**BEFORE THE ENERGY RESOURCES CONSERVATION AND
DEVELOPMENT COMMISSION OF THE STATE OF CALIFORNIA**

DOCKET No. 11-KGA-1

**Staff Request for Clarification on the Committee Decision of April 25, 2011,
Concerning the RPS Pre-certification Application of the SPGCA-1 Facility**

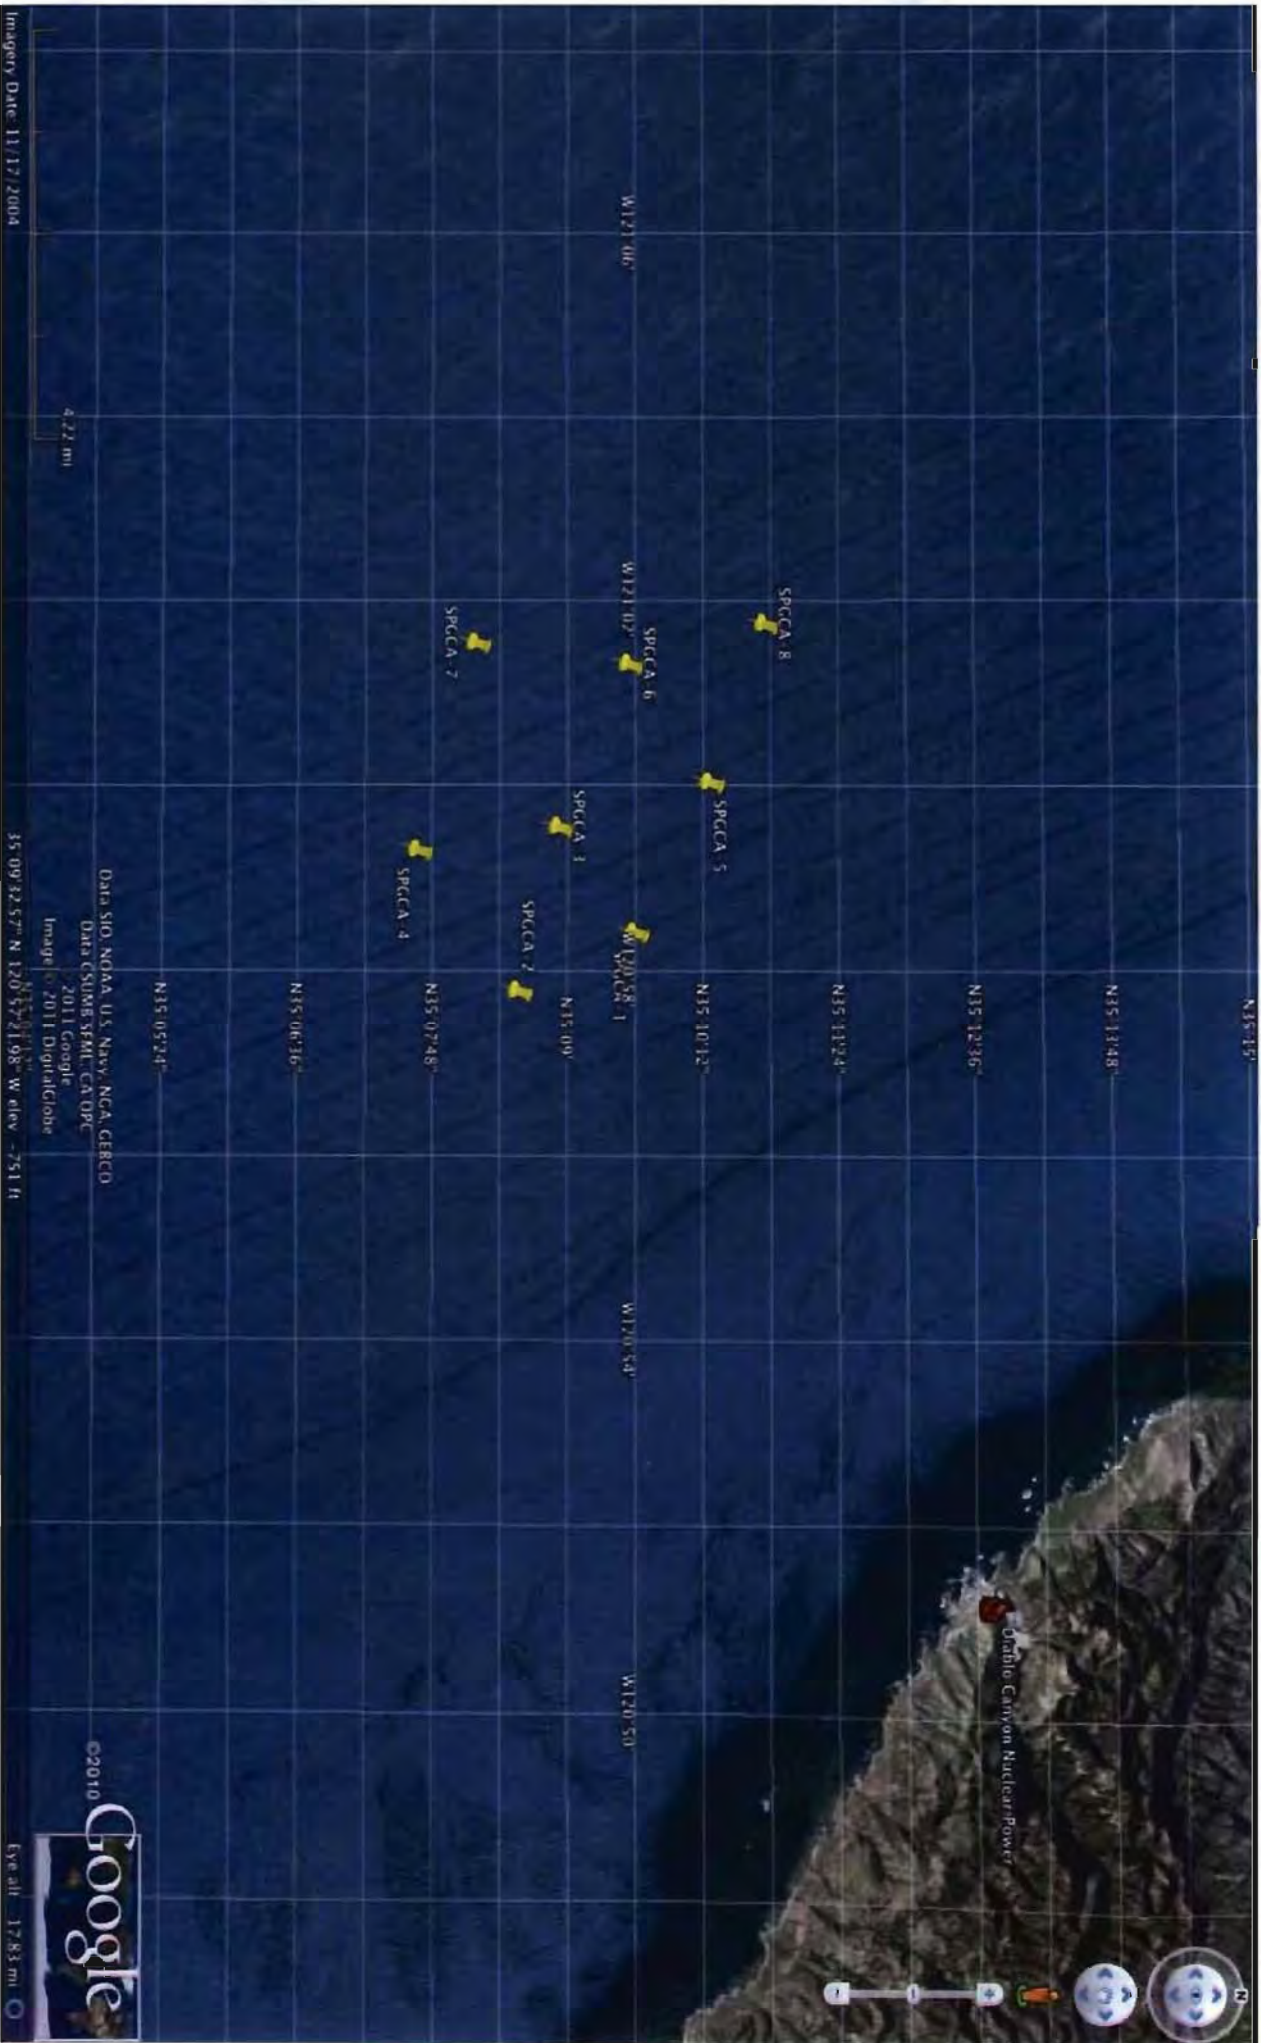
1. Item 5: The physical location of the facility provided in your email dated June 7, 2011, 35° 9' 36.04" N, 120° 58' 28.08" W, is not located in the ocean as described in the supplemental information provided with the August 2010 submission. Can you please confirm that this is the correct physical location, and if so please provide a brief explanation as to why the location of the facility is now on land. Please also provide a statement that the new location is correct and references in the original submission placing the facility in the ocean are no longer valid for this facility. If the location provided in your email is incorrect, please specify the correct physical location or grant the Energy Commission permission to strike this information from the form and as indicated in the Committee Decision "state, in writing, why the information is not yet available, and when it will be available."

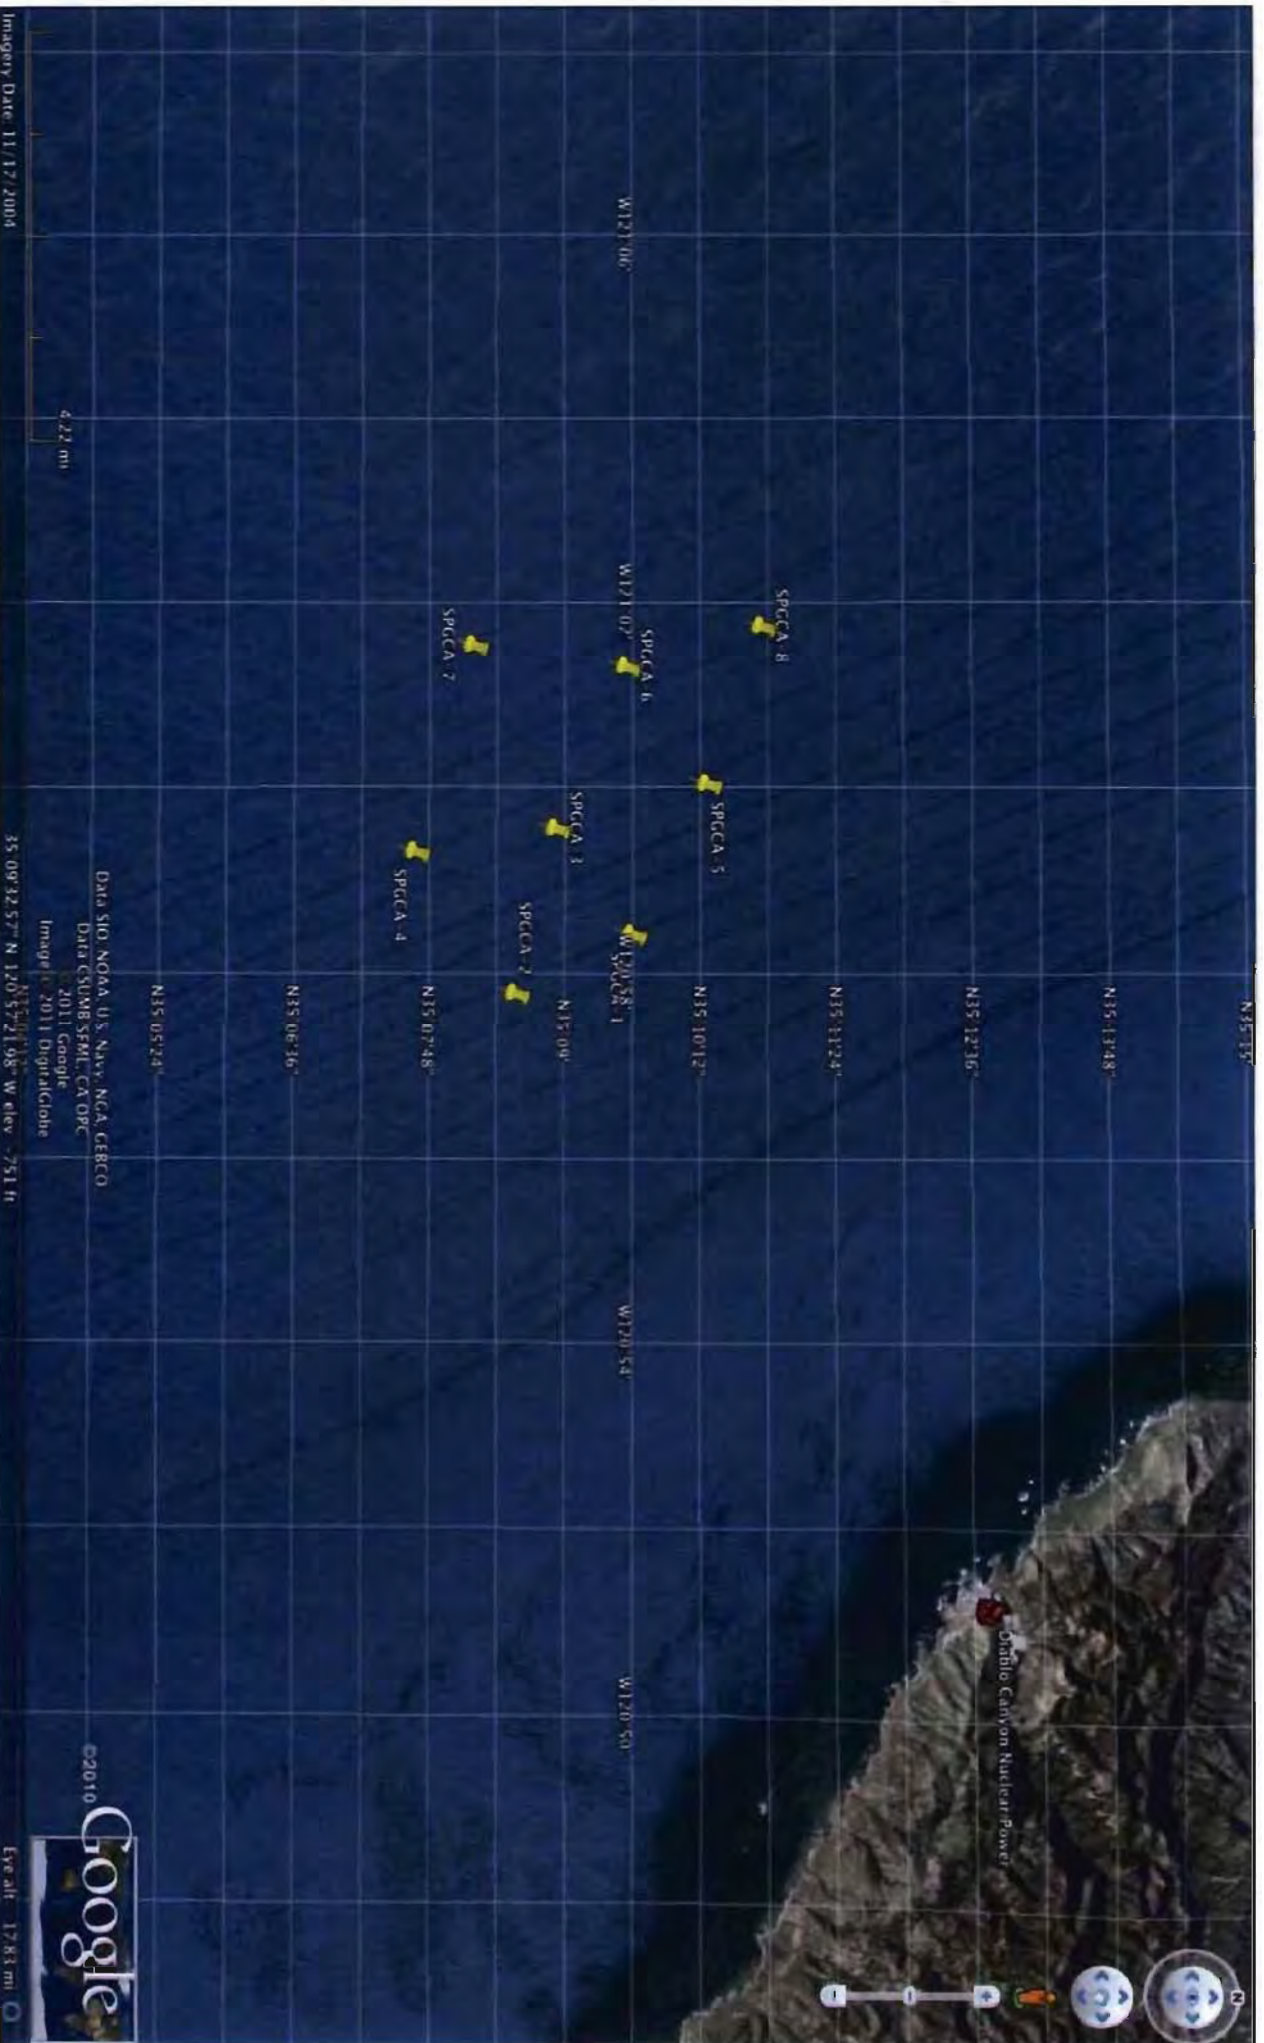
August 29, 2011	25 MW
Staff Notes	<p>Thank you for confirming the capacity of the SPGCA 1, LLC facility. Unfortunately, based on the location information you provided in the screen shot of the placement for the SPGCA 1, LLC in relation to SPGCA 2-8, one or more of the proposed facilities are within one mile of the SPGCA 1, LLC facility. It appears that the SPGCA 1, LLC, SPGCA 2, SPGCA 3, and possibly other SPGCA facilities as show in these screen shots would need to be treated as a single project or facility as defined in the Overall Program Guidebook, Second Edition. If this is the case the combined capacity of all these facilities must be taken into consideration for the certification of the SPGCA 1, LLC facility.</p> <p>Please address whether or not these eight units can be treated as separate projects of if they need to be certified as a single project per the definition in the Overall Program Guidebook, Second Edition.</p>

Diagram of Genergy Technology Presented During Committee Hearing

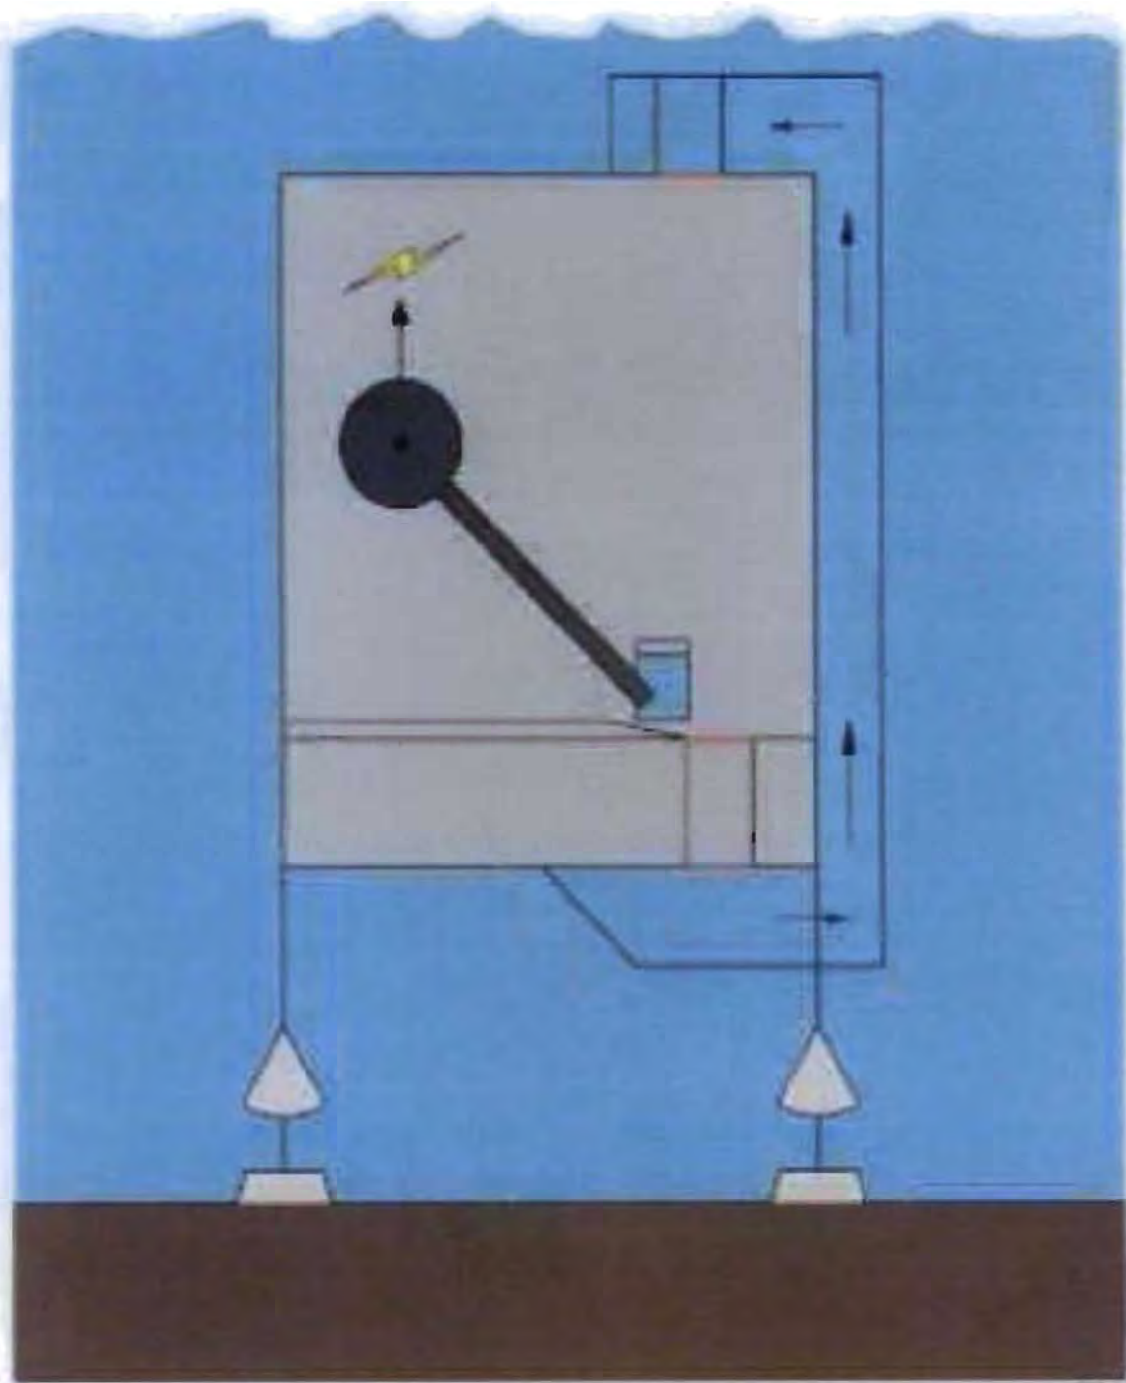
Based on the information provided by Mr. Grossman during the Committee hearing, including the diagram in Exhibit G, the Committee concluded that the SPGCA-1 facility was a "hydroelectric" facility, because it would use a technology that "uses falling water to generate electricity."¹⁴ It does not appear that the Committee Decision considered the use of linear generators in the SPGCA-1 facility. Consequently, staff recommends that Mr. Grossman either: 1) clarify that the SPGCA-1 facility will not use linear generators, or 2) amend the application for the SPGCA-1 facility to reflect that it will use linear generators as a nonrenewable resource in the electrical generation process. The latter option will also require the submission of a proposed accounting method to accurately differentiate between generation from the linear generators and generation produced by falling water.¹⁵
